ADDENDUM to INSTALLATION INSTRUCTIONS for

Grant Spira 6-26kW and 9-36kW Wood Pellet Boilers

DOC42-01/02 Rev02 - October 2014

Figure F: Hopper wiring enclosure (with cover removed)

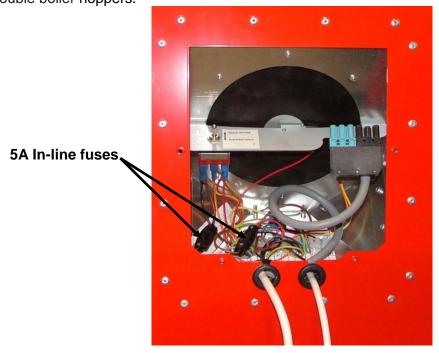
All Grant Spira boiler pellet hoppers are now fitted with two in-line 5A fuses. These are located inside the electrical wiring enclosure in the back of the pellet hoppers. Refer to Figure F below.

Figure H: Wiring diagram for double boiler hopper

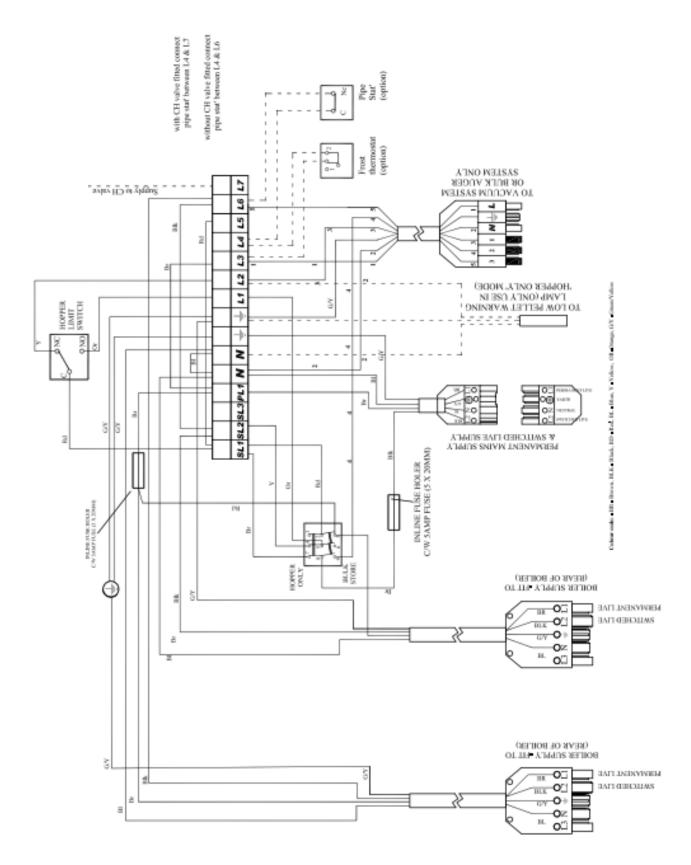
There has been a small change to the internal wiring of the Spira pellet hopper. This affects the information given in the following section of the Installation and Servicing Instructions:

Refer to Figures G and H for the revised electrical wiring diagrams for the single boiler and double boiler hoppers.
